July 2014  
FL655  
NHTSA #13V-605  
Transport Canada #13-423  
INTERIM RECALL BULLETIN  
REVISED NOTICE

## Subject: Sterling Bullet Left Tie Rod Ends

**Models Affected: Specific Sterling Bullet vehicles manufactured October 15, 2007, through November 10, 2008.**

**Fig. 1, Left Tie-Rod Alignment**

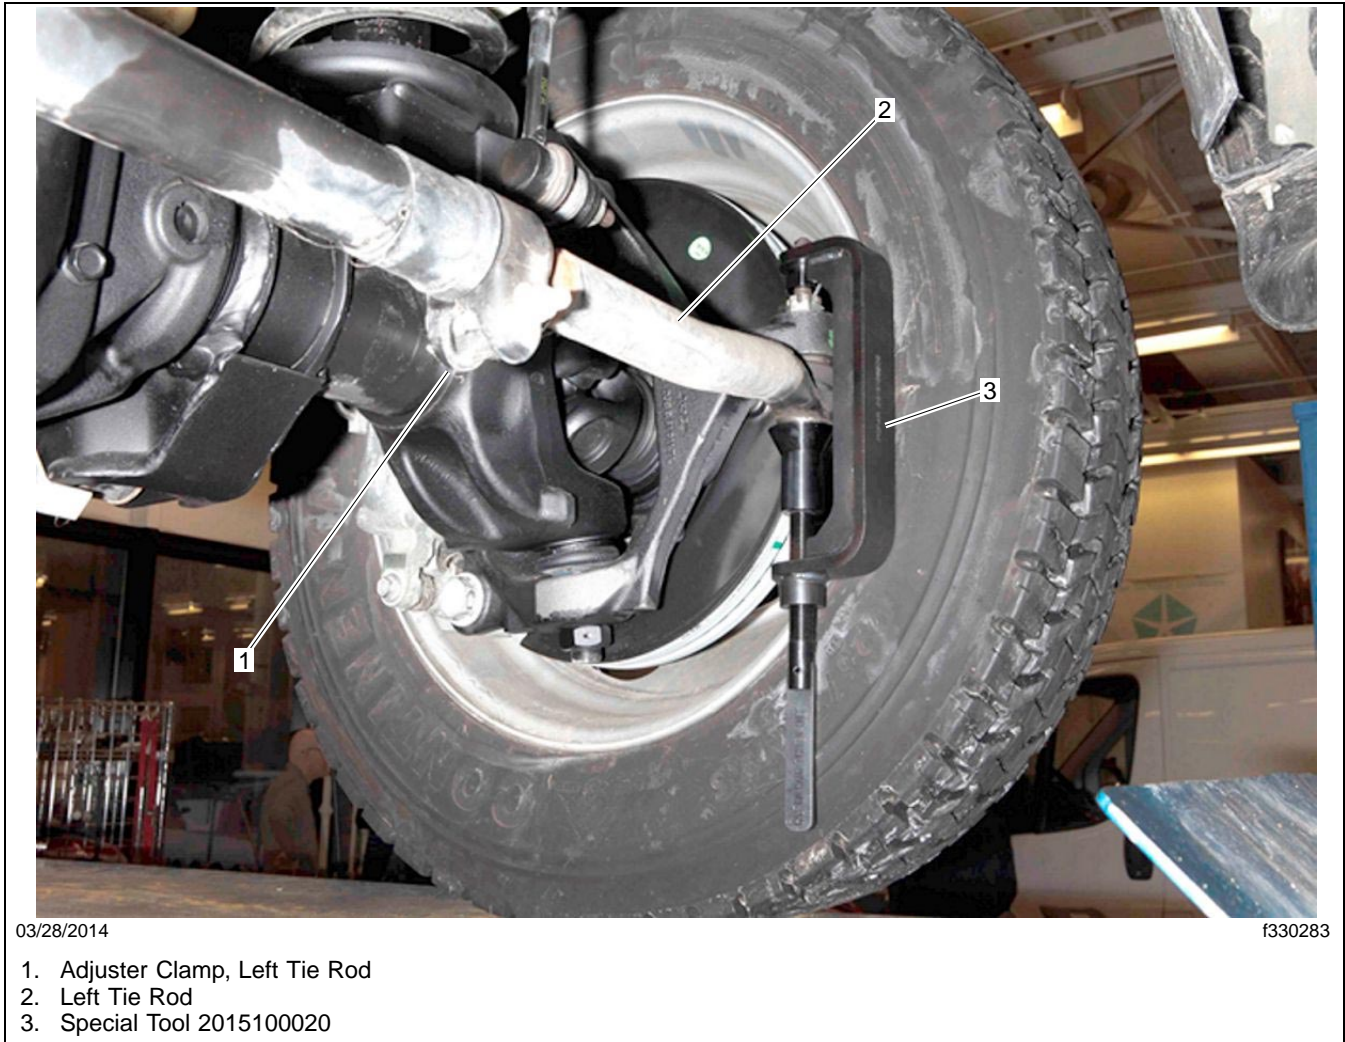
1. Park the vehicle on a drive-on type hoist with the front wheels in the straight ahead position, shut down the engine, and set the parking brake. Chock the tires.
2. Install special tool 2015100020 hand-tight onto the left tie rod as shown in **Fig. 1**.

If the bottom face of the tie rod is flush against the tool, the tie rod is properly aligned—remove the special tool and go to step 5 on page 6 of this bulletin.

If the bottom face of the tie rod is not flush against the tool, go to the "Tie Rod Alignment" section of these instructions.

1. Ensure the vehicle meets the following criteria before measuring the tie-rod end angles.
  - vehicle is parked on a level surface
  - full vehicle weight is on the front tires
  - bottom sides of both tie-rod ends are clean
  - bottom sides of both tie-rod ends are free of burrs
2. Set the toe and center the steering wheel following the alignment rack manufacturer's instructions.
3. Install special tool 2015100020 onto the left tie rod as shown in **Fig. 1** and hand-tighten it until the bottom face of the tie rod is flush against the tool.
4. Tighten the left tie rod adjuster clamp nut and bolt to 66 lbf·ft (90 N·m).
